## Addendum to the

# Apple II Reference Manual

The main logic board of your Apple has been modified to reduce electromagnetic interference. This means that it is different from the Apple boards which are described in the Apple II Reference Manual. It will not, however, behave differently in any specific way unless you have changes made to it.

Replaces Figure 22-1. Schematic Diagram of the Apple II

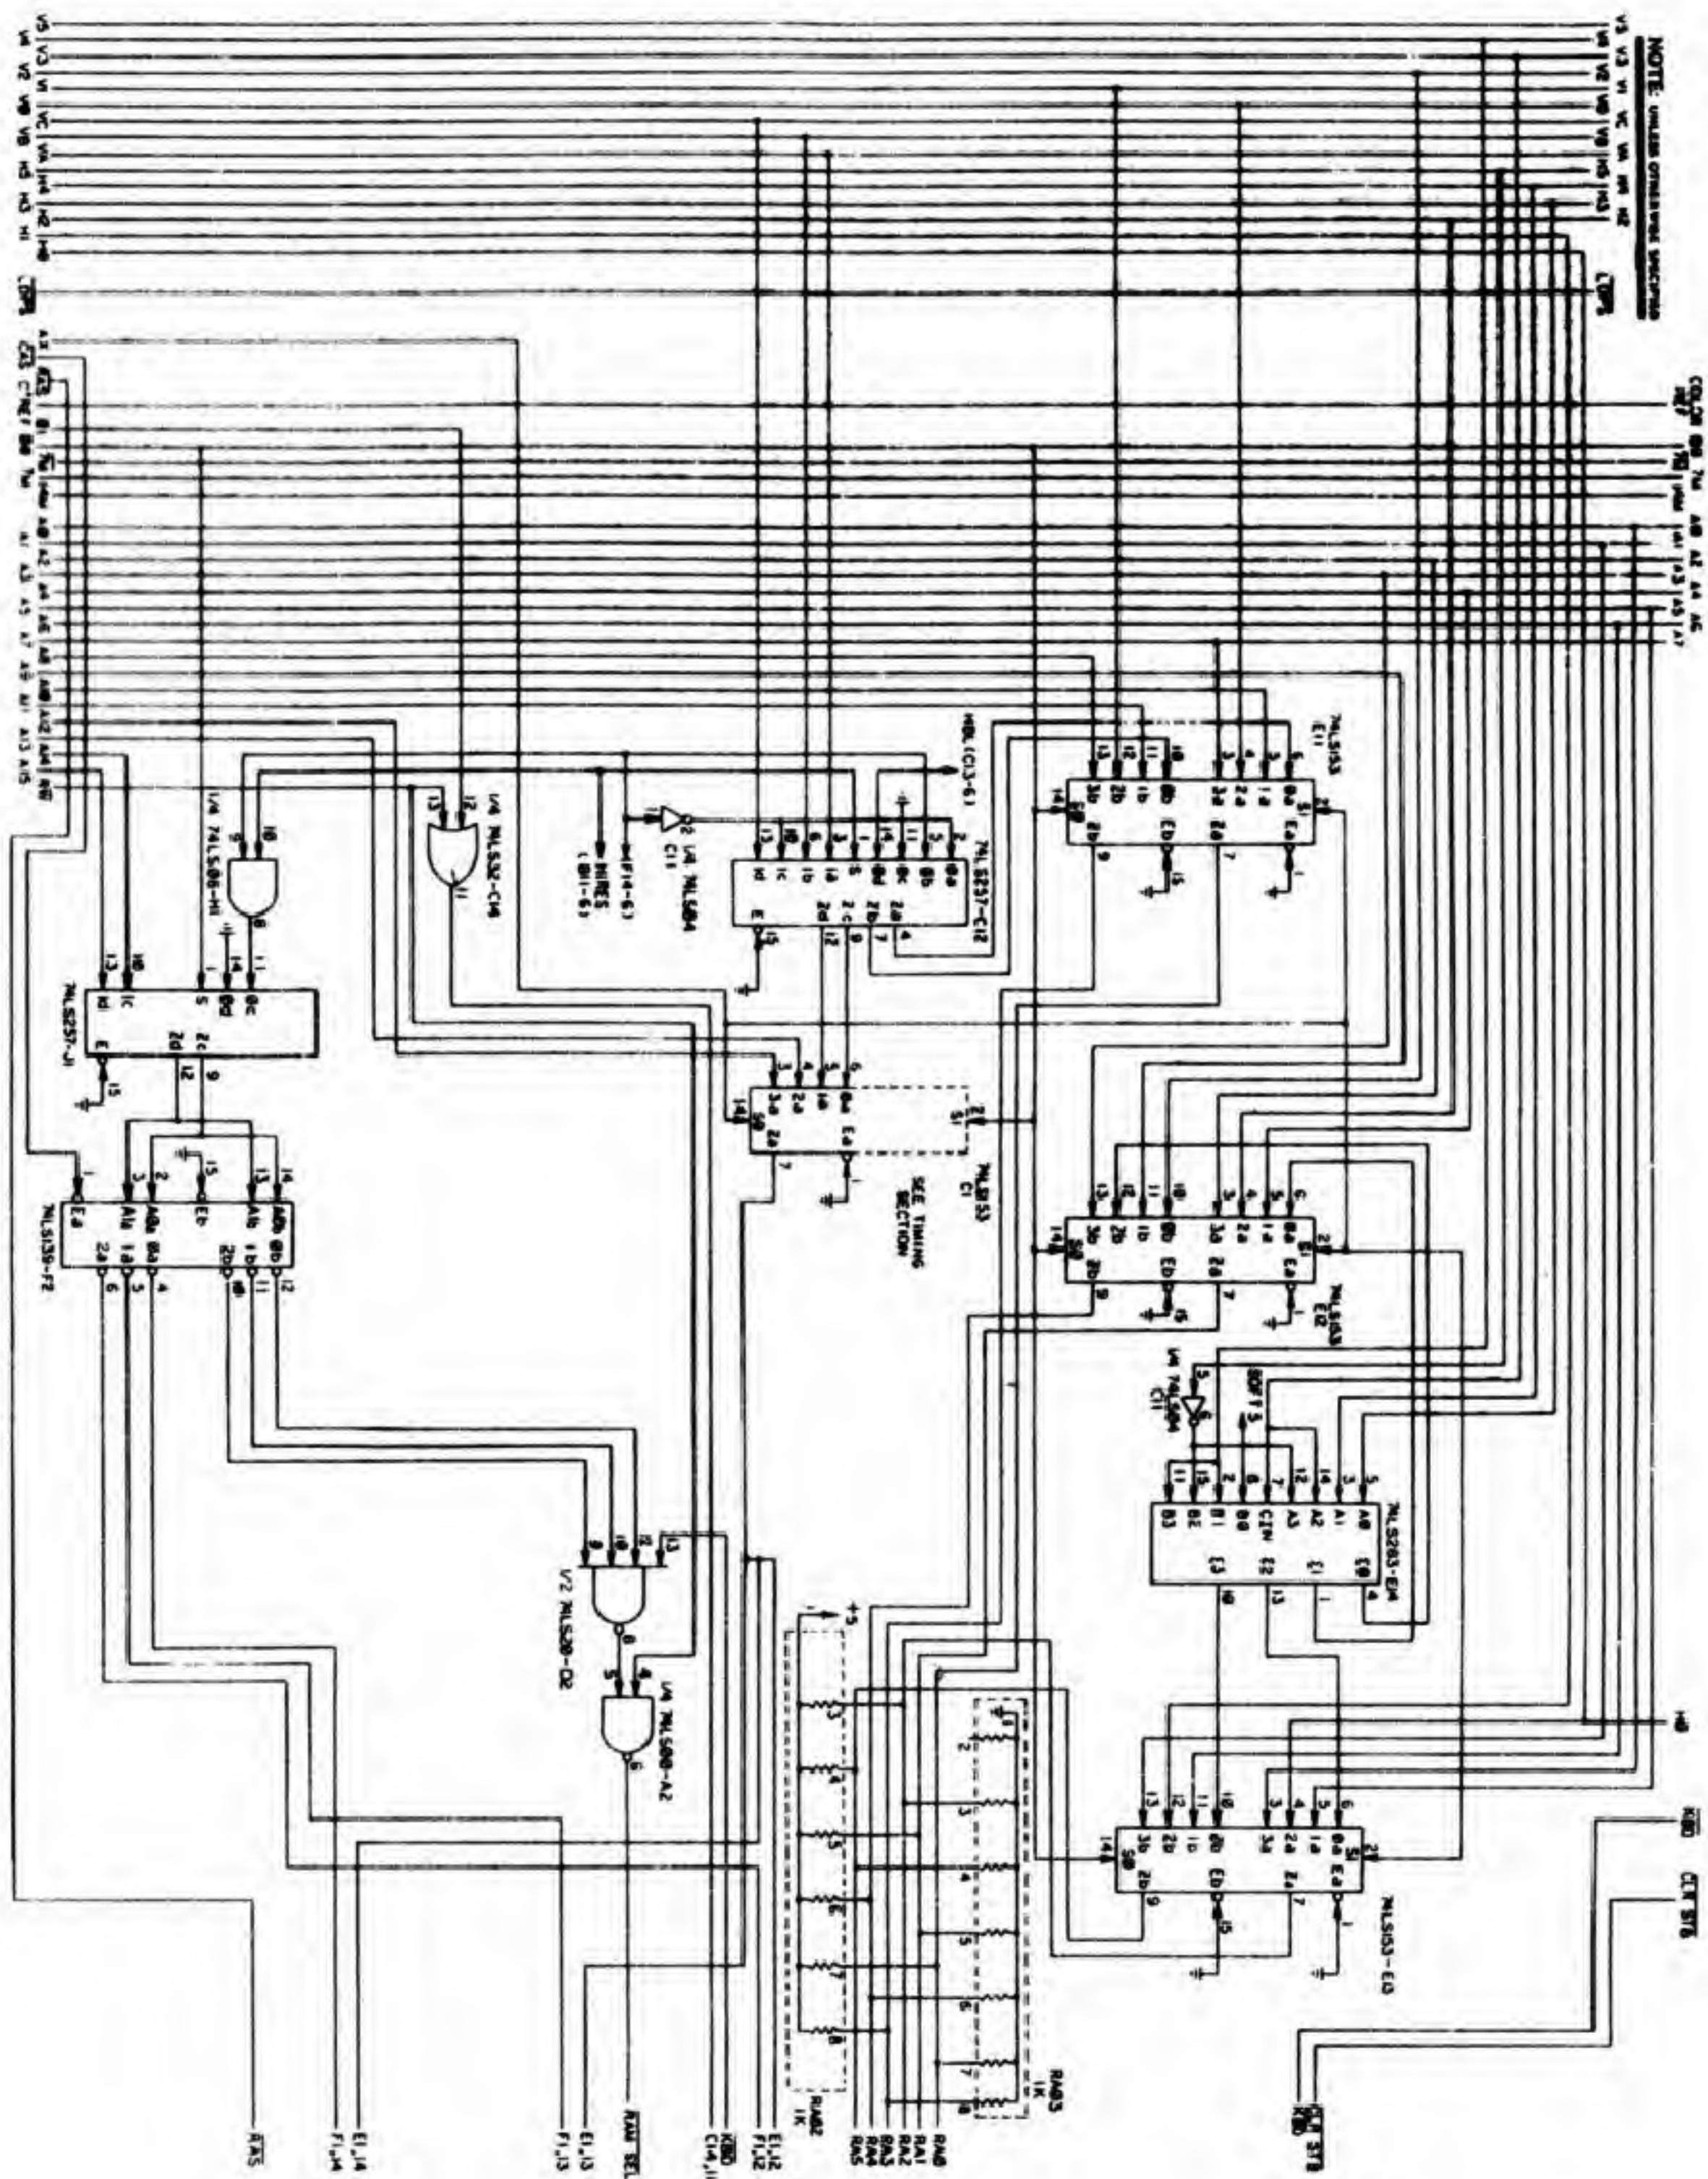
The major differences in the new main board are described below. Also, the attached schematics show the areas in which this board is different from earlier boards. You may wish to note these differences in your Apple II Reference manual, on the pages which correspond to the schematics here.

- \* The new board does not have RAM configuration blocks. This means the RAM Integrated Circuits (ICs) which give your Apple its memory MUST be 16K bit ICs. All of the RAM ICs in your Apple are within the white-outlined box on the board. If you add memory to your Apple, make sure all the ICs you add in this box are 16K Apple RAM.

- \* The IC which controlled the configuration blocks in the older versions of the Apple II board is no longer there. It was formerly in the E2 position on the Apple board (in the row labeled E, the second IC from the left of the board) and was marked 74LS139.

Replaces Figure 22-3. Schematic Diagram of the Apple II

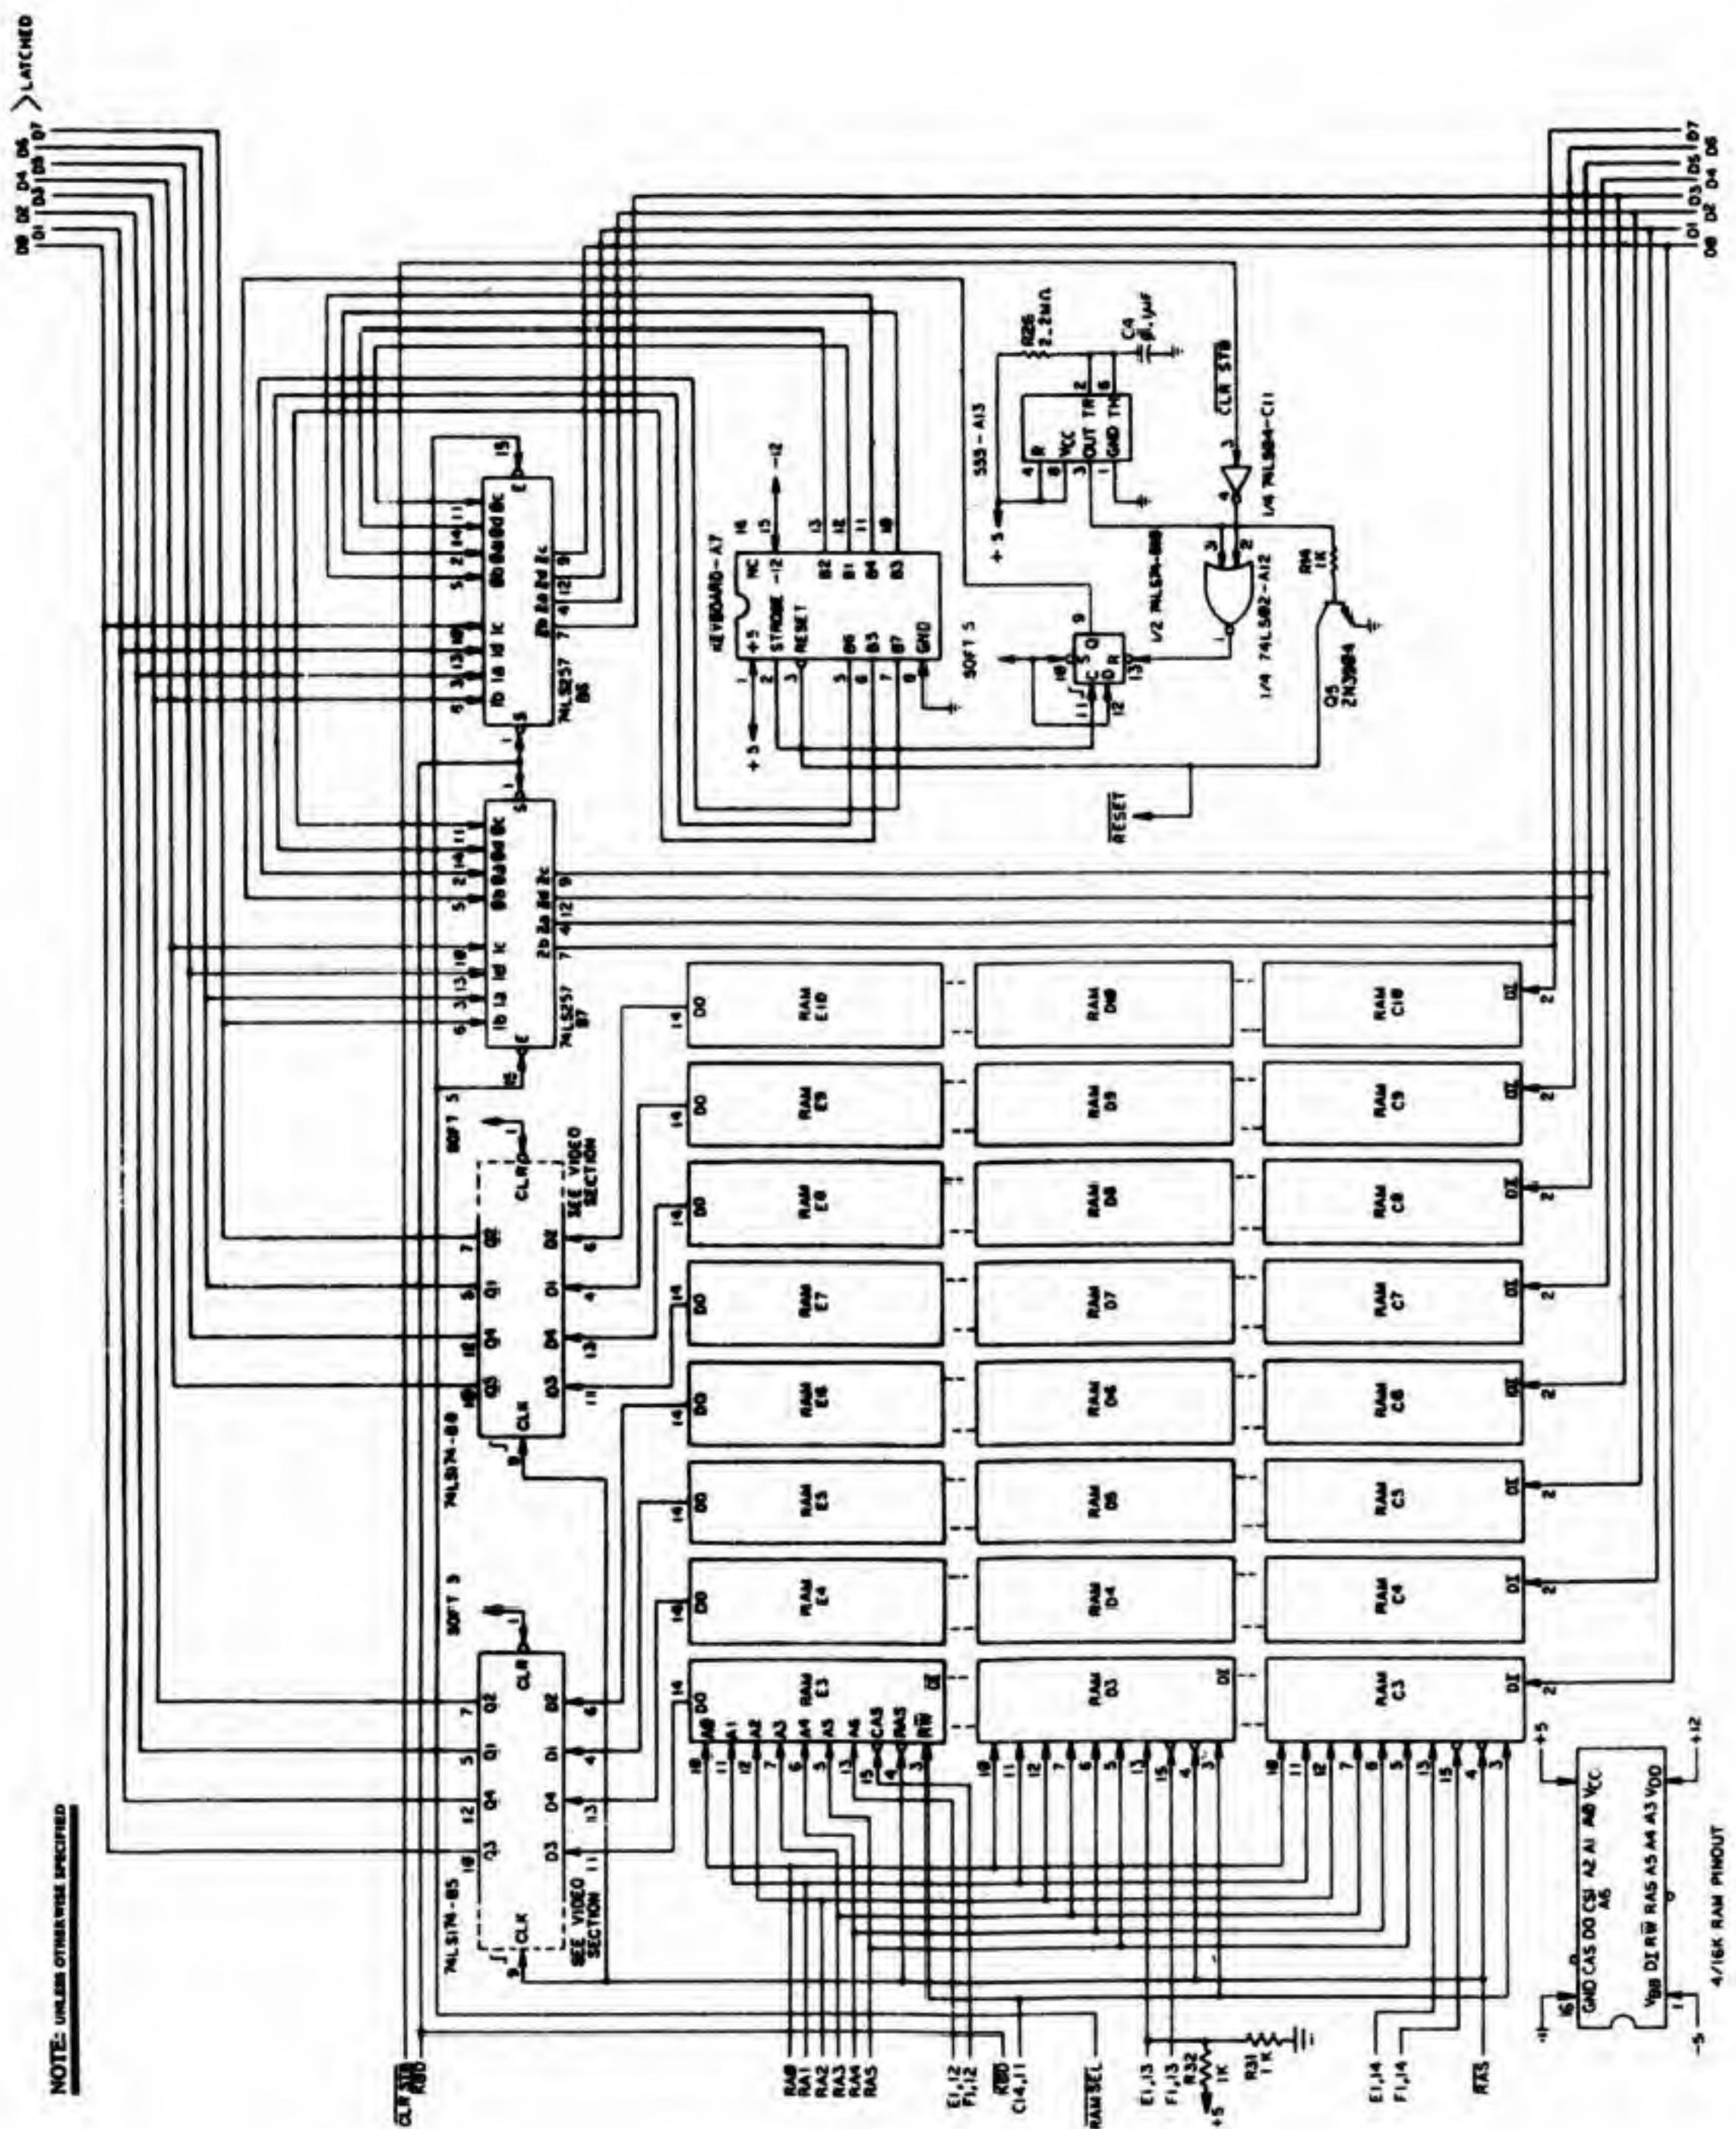
- \* An inverter circuit has been added in the H2 line, which is a video synchronization signal. This alters the video synchronization pulse rate of the Apple so that it is more compatible with video monitors that have digital synchronization circuitry.
